Access Compliance Report

Public Rights-of-Way

Intersection ID: 28345	Main Street: BACARDI_CT	Cross Street: HIRSCH_DR	Location: SE
ADA ID: B1EFAE09CD53	Ramp Type: Perp	Initial Pass/Fail: Fail	Overall Compliance: No
		Severity Score: 30

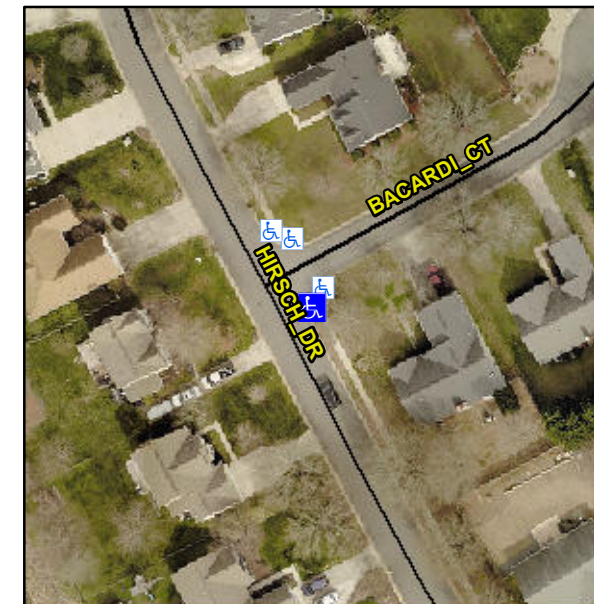
Not Found, R304.5.1, R304.5.3

Compliance	Description	Data	Compliance	Description	Data
N/A	Ramp Length (in)	93.0	Yes	Ramp Slope (%)	6.6
No	Ramp Width (in)	32.0	No	Ramp XSlope (%)	6.9
N/A	Flare Type LT	N/A	N/A	Flare Type RT	N/A
N/A	Flare Slope LT (%)	N/A	N/A	Flare Slope RT (%)	N/A
N/A	Flare Traversable LT?	N/A	N/A	Flare Traversable RT?	N/A
N/A	Landing Length (in)	N/A	N/A	DWS Provided?	N/A
N/A	Landing Width (in)	N/A	N/A	DWS Contrast?	N/A
N/A	Landing Slope (%)	N/A	N/A	DWS Length (in)	N/A
N/A	Landing X Slope (%)	N/A	N/A	DWS Full Width?	N/A
N/A	Landing Curb? (Y/N)	N/A	N/A	DWS Offset (in)	N/A
N/A	Shared Landing?	N/A			
N/A	Gutter Ponding?	N/A	N/A	Gutter Slope (%)	N/A
N/A	Gutter Lip Ht (in)	N/A	N/A	Gutter X Slope (%)	N/A
N/A	Painted X Walk1?	No	N/A	Painted X Walk2?	N/A
	X Walk 1 Direction	To SW		X Walk 2 Direction	N/A
N/A	X Walk 1 Width (in)	N/A	N/A	X Walk 2 Width (in)	N/A
	X Walk 1 Slope (%)	1.3		X Walk 2 Slope (%)	N/A
	X Walk 1 X Slope (%)	3.3		X Walk 2 X Slope (%)	N/A

Remove & Replace Entire Ramp.
